SUBMISSION: TRAHAIR

a written submission by way of objection to DA 2021/1814

Re: 58 Forest Way, Frenchs Forest, NSW 2086 DA 2021/1814

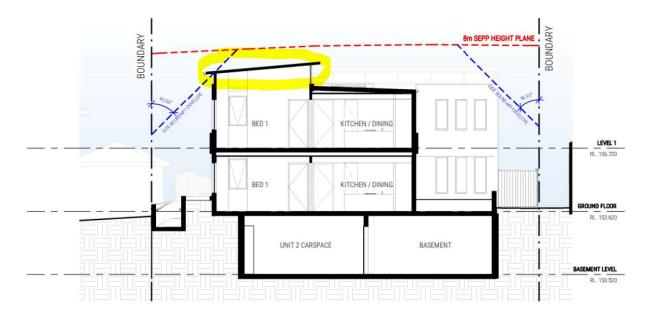
Shadow diagrams have been produced which are based on an existing 1.8 metre high solid fence. As per our submission to the previous development application (DA2020/1287) this is inaccurate as there is only a 1m wire mesh fence between 56 and 58 Forest Way, which does not currently produce any shadow. Overshadowing by fences must be taken into consideration. The shadow diagrams therefore

greatly underestimate the impact that the proposed development will have on our property in terms of solar access. Our solar access in our main private open space/outdoor area will be significantly reduced.
